Galway County Council

February 2022

**PROPOSED HOUSING DEVELOPMENT
AT BALLYMOE, COUNTY GALWAY
Stage 1 Road Safety Audit**

Figure 2.2: Widened Footway Area

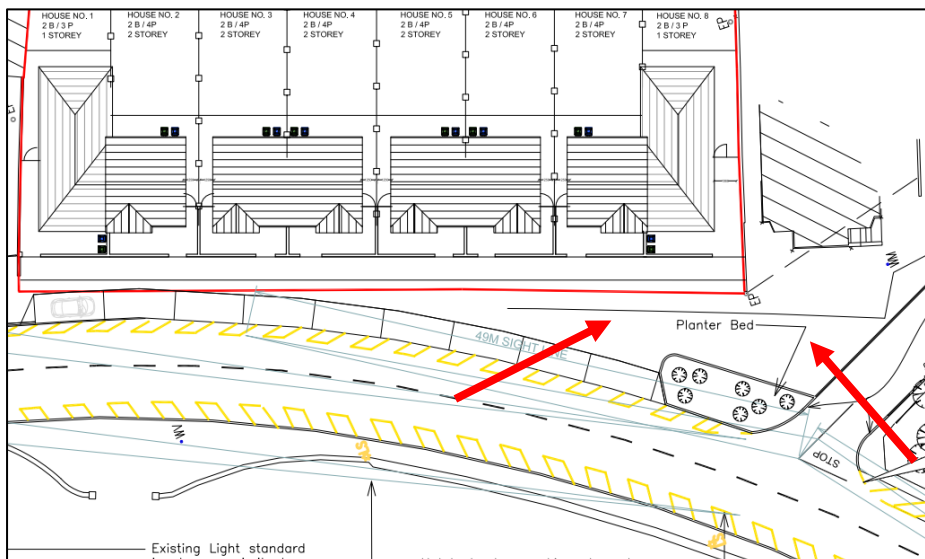
2.2 Problem – Possible Inappropriate Parking

It is understood that a new footway build-out is proposed along the R360, with a widened footway area at the south end of the scheme, between the proposed houses and recessed parking/planter box. This footway area could be accessed by vehicles for parking, via the recessed parking area and adjacent cul-de-sac local road. The existing east side footway is at-grade with the adjacent road carriageway. Inappropriate parking could result in material damage to footways and kerbs, and conflicts, impact collisions and injuries for pedestrians.

Recommendation:

It is recommended that appropriate levels and measures should be provided to prevent inappropriate parking. Refer also to item 2.1 above.

Figure 2.3: Planter Box Flush With Recessed Parking

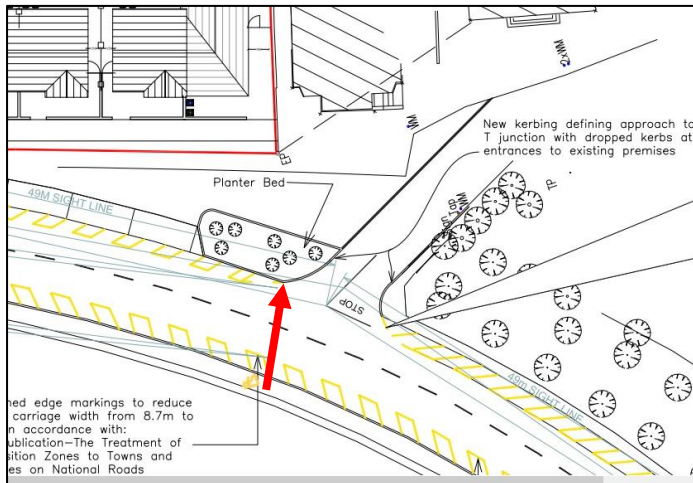
2.3 Problem – Planter Box on Possible Pedestrian Desire Line

It is proposed to provide a planter box with landscaping, on the north side of the cul-de-sac local road junction, immediately flush with the proposed recessed parking. The existing R360 east side footway is discontinued south of the local road junction. This could restrict pedestrian movements at this location, including pedestrians using the Suck Valley Way walking route and pedestrians generated between the proposed housing and south along the R360, resulting in potential conflicts, collisions, trips, falls and injuries.

Recommendation:

It is recommended that pedestrian desire lines should be kept clear of restrictions, with appropriate footway treatments.

Figure 2.4: Hatched Road Markings

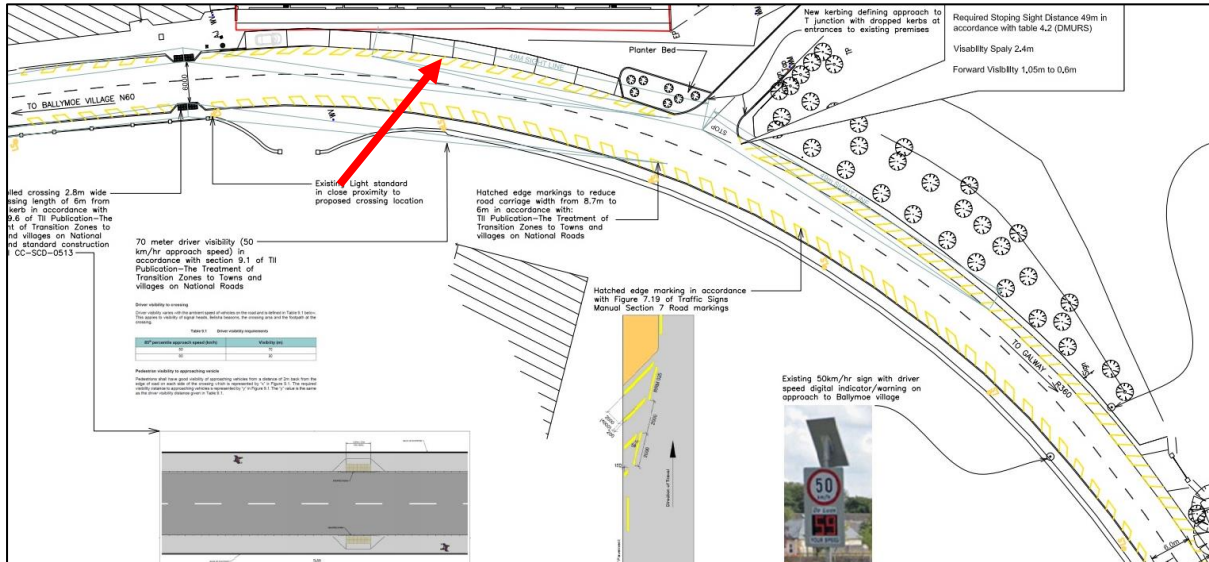
2.4 Comment – Incorrect Hatched Road Markings

Although a Stage 2 item, the directional orientation of the proposed hatched road markings along the east side of the R360 are shown incorrect on the drawing provided for audit. It is recommended that the markings should be orientated correctly for the adjacent southbound traffic lane direction.

Paragraph No. in Safety Audit	To Be Completed By Designer			To Be Completed by Audit Team Leader
	Problem Accepted (Yes/ No)	Recommended Measure Accepted (Yes/ No)	Describe Alternative Measure(s). Give Reasons for Not Accepting Recommended Measure	Alternative Measures Accepted by Auditors (Yes/ No)
2.1	YES	YES		
2.2	YES	YES		
2.3	YES	YES		
2.4	YES	NO	Improved road design by applying DMURS and providing footpaths & kerbs instead of the line marking hatching only	Yes
2.5	YES	YES		
2.6	YES	YES
